CLASS 1 MODIFICATIONS TO THE HANFORD FACILITY RESOURCE CONSERVATION AND RECOVERY ACT PERMIT, QUARTER ENDING JUNE 30, 2012

CLASS 1 MODIFICATIONS FOR QUARTER ENDING JUNE 30, 2012

Hanford Facility RCRA Permit Modification Notification Forms

HLP-VSL-00022
MIXING ASSESSMENT
EQUIPMENT CHANGES
SECTION AND DETAIL VIEWS
SHEET 4 OF 4

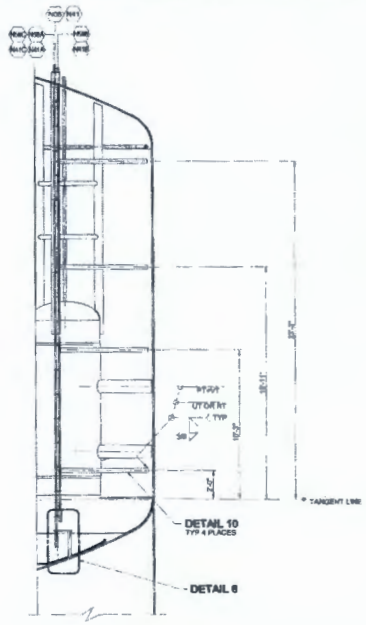
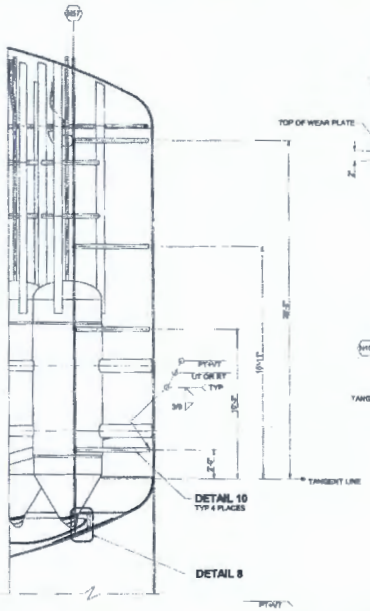
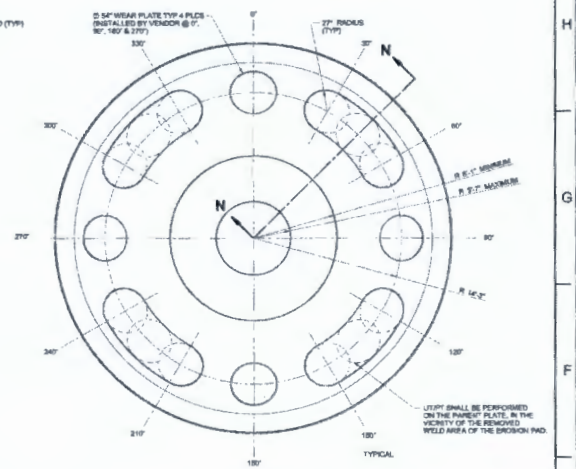
REVISED PUM VESSEL ASSEMBLY CONFIGURATION SHOWN IN SECTIONS J-J AND K-K. DETAIL 12 FOR 8DS AND NEW SUPPORT CONFIGURATION. WELD REQUIREMENT FOR 4" X 1/2" THK PLATE SHOWN IN DETAIL 11.

DELETED DETAIL 12.

ADDED: SECTION T-T, V-V AND W-W.
NDE REQUIREMENT FOR 6W" PIPE SHOWN IN SECTION Q-Q.
NDE REQUIREMENT FOR 6S" PIPE SHOWN IN DETAIL 13.
NDE REQUIREMENT FOR 6S" PIPE SHOWN IN DETAIL 10.
NDE REQUIREMENT FOR 8S" PIPE SHOWN IN DETAIL 6
NDE REQUIREMENT FOR 8S" PIPE SHOWN IN DETAIL 8.

HLP-VSL-00022
MIXING ASSESSMENT
EQUIPMENT CHANGES
PLAN, ELEVATION AND SECTION VIEWS
SHEET 2 OF 4

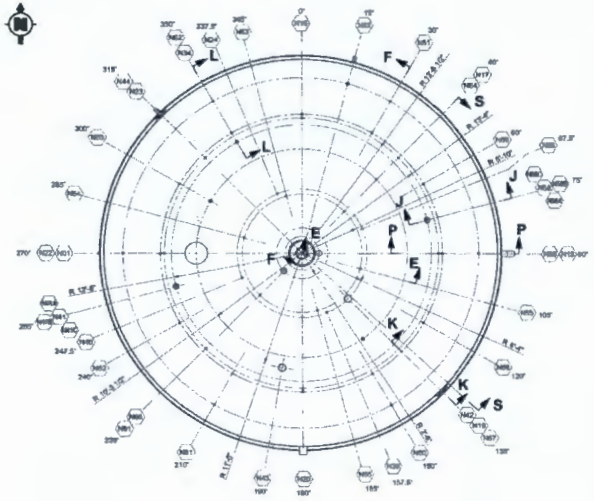
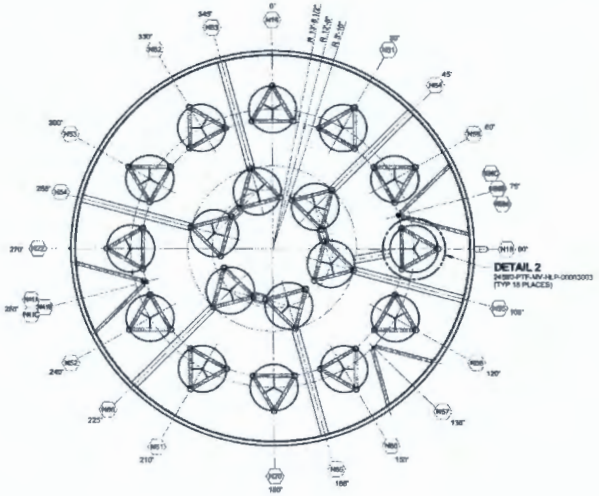
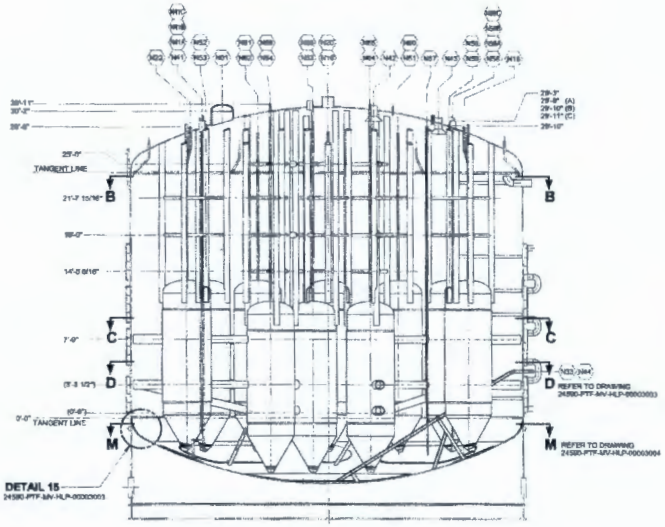
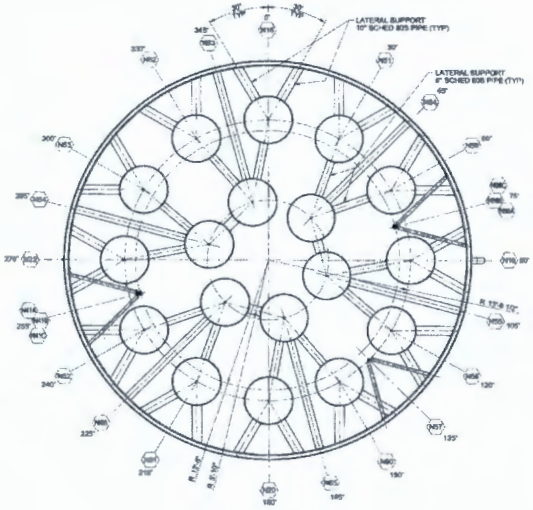
DELETED: NOTE 3

Figure 1 LAW Structural Attachment Design Requirements

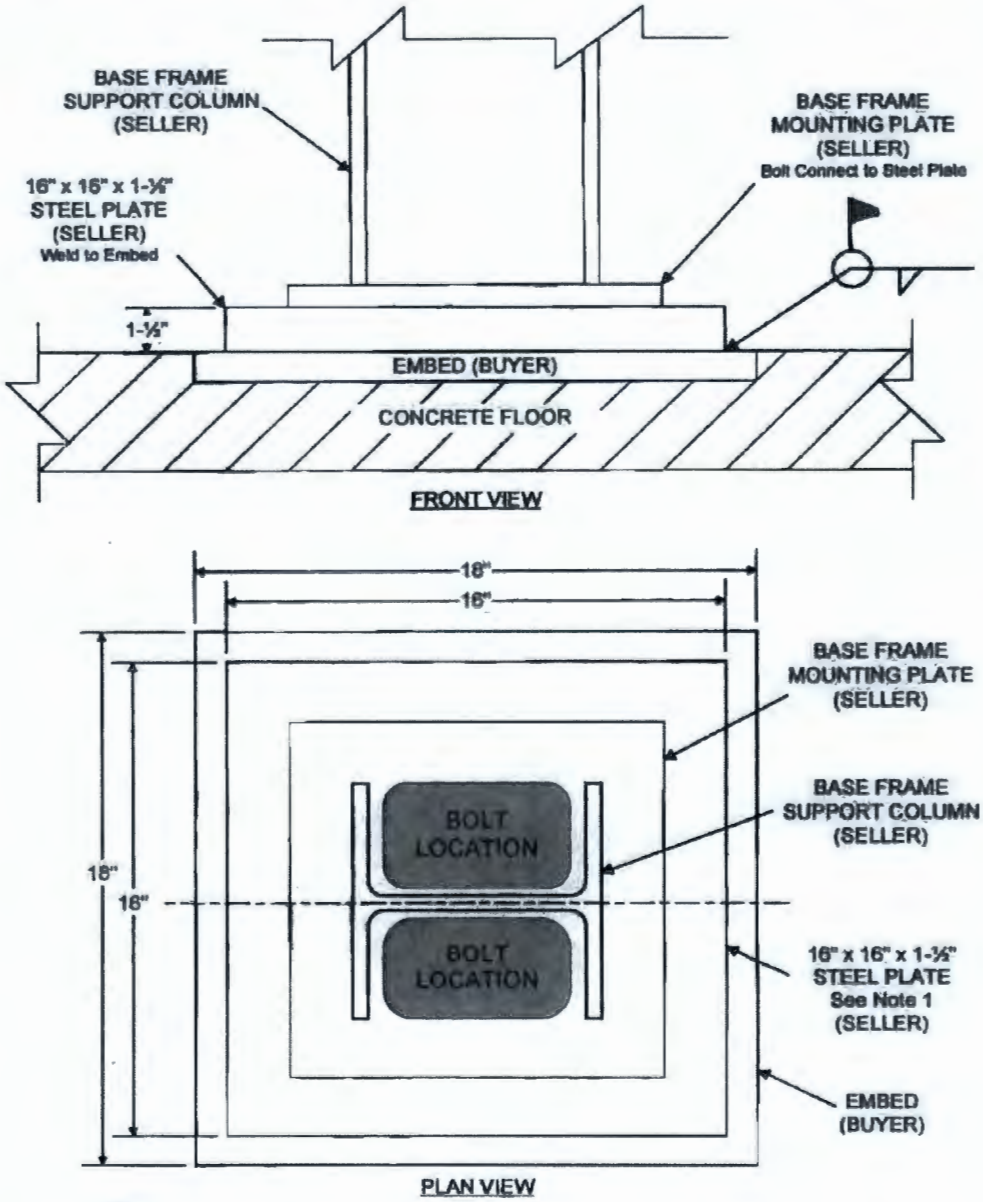
Note: Figure 4 from TCN, 24590-QL-MRA-MWK0-00001-T0001, incorporated as Figure 1
